Chapter 2

Responses to Comments

The Draft Environmental Impact Report (EIR) prepared for the Los Angeles Harbor Department (LAHD) was distributed to the public and regulatory agencies on October 12, 2023, for a 45-day review period; the review period was subsequently extended to 60 days, ending on December 11, 2023. Printed copies of the Draft EIR were available for review at the Los Angeles Harbor Department, Environmental Management Division, 425 S. Palos Verdes Street, San Pedro, CA 90731. In addition to printed copies of the Draft EIR, digital copies were made available. Due to the size of the document, the digital copies were prepared as a series of PDF files to facilitate downloading and printing and were available on the Port web site at <https://www.portoflosangeles.org/environment/environmental-documents>. Interested parties were required to provide written comments on the Draft EIR, which must have been postmarked by December 11, 2023.

Figure 3.1-2: Isoleths of 30-Year Residential Cancer Risk – Proposed Project

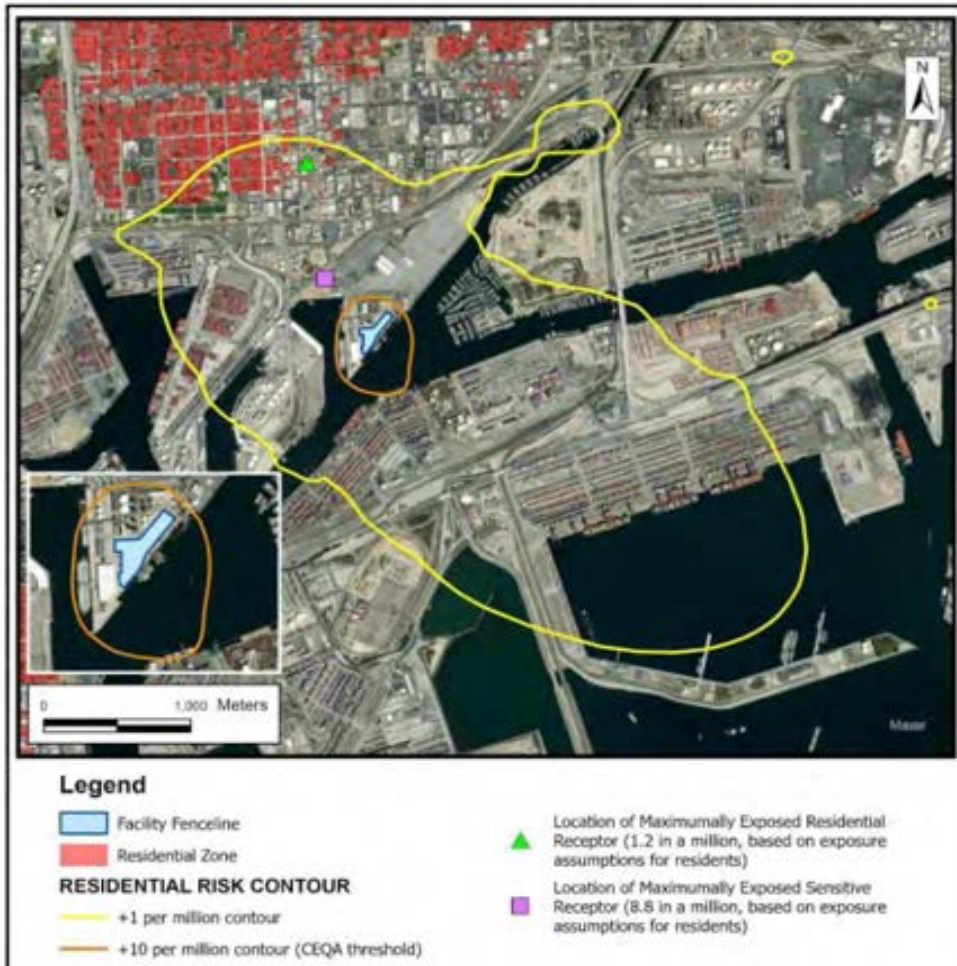
CESPNC-3

Health risks are also a concern. CEQA does not require evaluating health risks unless they exceed more than 10 per million cancer cases. The DEIR found no cancer risk requiring an assessment. However, Figure 3.1–2 in the DEIR shows two risk outlines, one encompassing the project site as well as the adjacent Vopak terminal and another encompassing numerous residences in Wilmington, at least four terminals in the Port, plus the adjacent marinas. Given the claim that the project does not exceed the CEQA impact requirement, this should be clarified. The DEIR also ignores the considerable data available that shows various important pulmonary impacts, especially on workers and children, such as COPD and asthma.

41 As indicated in the comment, the significant CEQA threshold for cancer risk is 10 in 1
42 million. As shown in Figure 3.1-2 of the Draft EIR, the cancer risk for residents
43 (including children) at the maximally exposed residential receptor location is 1.2 in 1
44 million, well below the threshold of significance. The cancer risk estimate of 8.8 in 1
45 million at the maximally exposed sensitive receptor location (recreational) is also below
46 the 10-in-1-million threshold of significance (DEIR, p. 3.1-38 [Table 3.1-14]). Note that
47 the cancer risk at the maximally exposed sensitive receptor (the Los Angeles World

12 The 10-in-1-million risk contour (the orange contour in Figure 3.1-2), which shows the
13 area where residential risk would be significant if anyone lived there, is close to the site
14 and does not reach the nearby residential neighborhood, which is over 3,000 feet away.
15 The 1-in-1-million risk contour (the yellow contour in Figure 3.1-2, which encompasses a
16 very small portion of the residential neighborhood) is shown for informational purposes
17 only and does not represent the CEQA significance threshold for cancer risk.

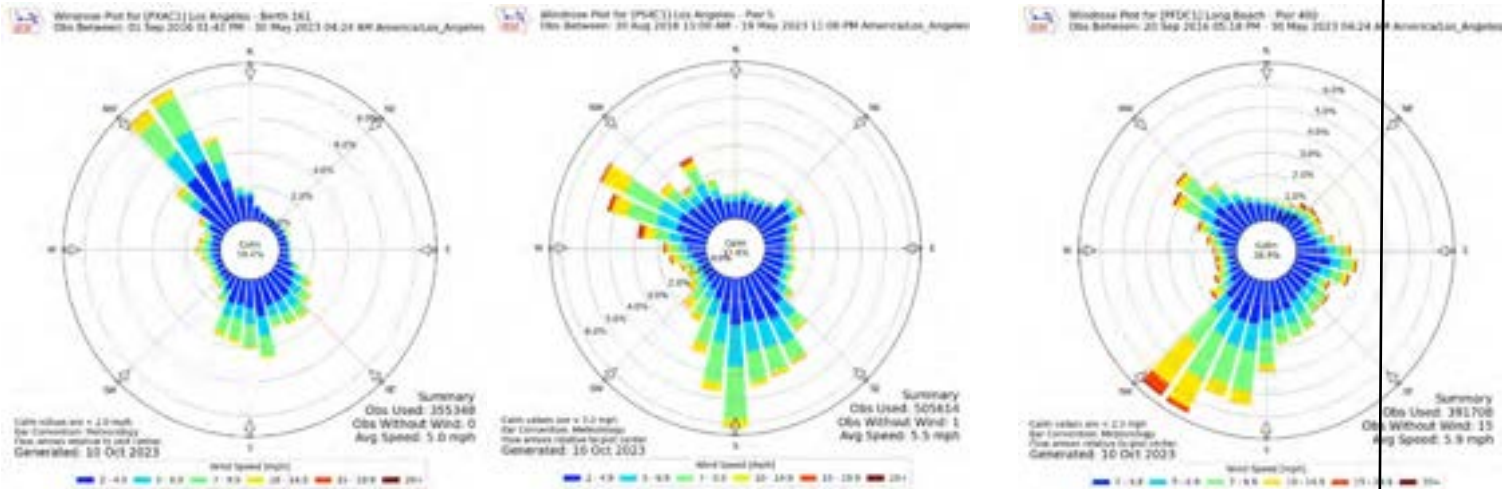
Per Section 3.1.3, page B2-11 of the EIR:

For this dispersion analysis, the meteorological data collected at the Wilmington Community Station, located at Saints Peter and Paul School (SPPS) from 2012 to 2016 was used for dispersion modeling. SPPS is located about 1.2 miles north-northwest of the Berths 191-194 terminal and is considered the most representative meteorological station for the terminal in accordance with an analysis conducted by POLA and POLB in 2010 (LAHD 2010)

The Guideline on Air Quality Models (the Guideline) contains the EPA's specifications for completion of air dispersion modeling analyses for regulatory purposes.²² EPA stresses that meteorological data should be adequately representative and may be site specific or from a nearby national weather service (NWS) station. If nearby NWS data are used, a five-year period must be utilized or if site specific data are used, a period of at least one year must be utilized, with added years of site-specific data (up to five years) used if available. In Section 8.4.1 of the Guideline, EPA provides criteria for evaluation of the representativeness of meteorological data for the project site. According to the Guideline, the representativeness of a particular observation site should be evaluated with respect to four factors:

1. The proximity of the meteorological monitoring site to the area under consideration;
2. The complexity of the terrain;
3. The exposure of the meteorological monitoring site; and
